Číslo výkresu /drawing number/:702-53pumpcontrol103

Nazev listu/sheet name/:ProjectInfo.SchDoc

DPS projekt/PCB project/:702-pumpcontrol

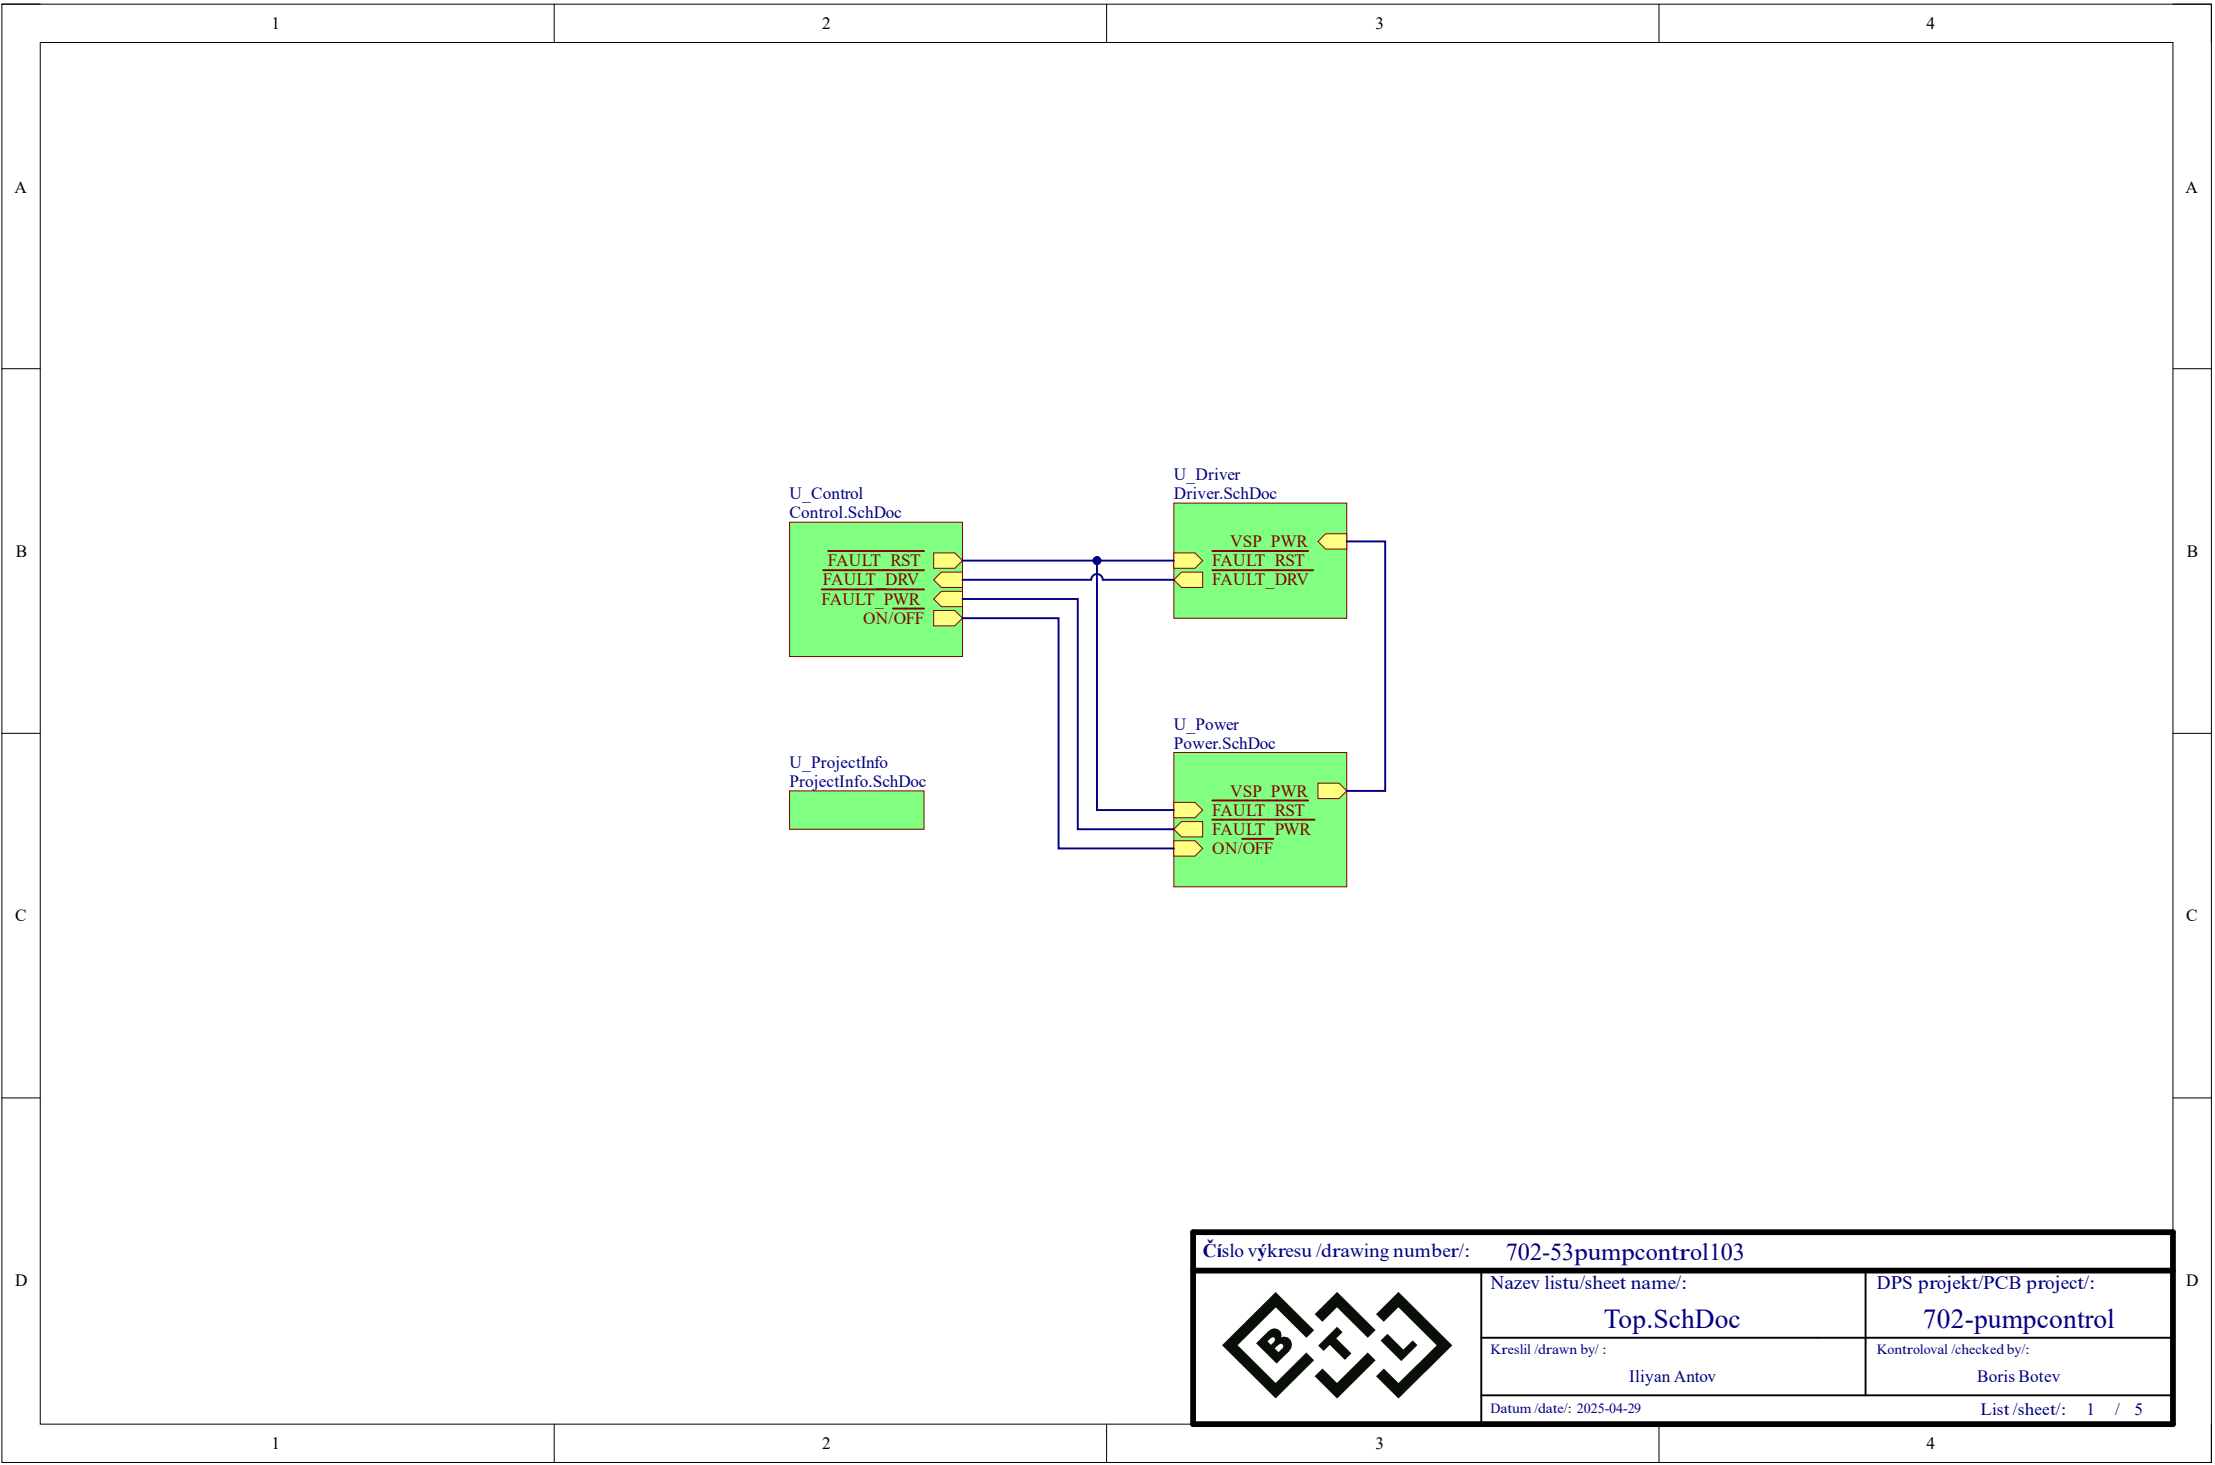
1		2		3		4		
A	Revisions table							A
	Revisions:	Description of changes:	Drawn by:	Checked by:				
	100	Initial version	Vasil Zarkov	Boris Botev				
	101	Control connector moved. Control circuit supplied by permanent +3v45ctrl (from +24V1) to support Sleep/Wake mode. Added R2 to prevent possible current into the 5v5 tollerant Speed/Wake input.	Vasil Zarkov	Boris Botev				
	102	Motor driver replaced and driver/generator communication redesigned. +3.45V power supply removed. +15V and +3.3V power supplies added. PCB completely redesigned.	Iliyan Antov	Boris Botev				
B	103	Control signals pull-up and pull-down resistors reduced. +15V and +3.3V power supply status LEDs added. Output snubbers reworked.	Iliyan Antov	Boris Botev				B
C								C
D	M3 TNP M3 TNP M3 TNP M3 TNP S1 BTL S2 CROSSED BIN LB1 2D FM1 FM2 FM3 FM4							D
	Číslo výkresu /drawing number/: 702-53pumpcontrol103 Nazev listu/sheet name/: ProjectInfo.SchDoc Kreslil /drawn by/: Iliyan Antov Datum /date/: 2025-04-29 DPS projekt/PCB project/: 702-pumpcontrol Kontroloval /checked by/: Boris Botev List /sheet/: 2 / 5
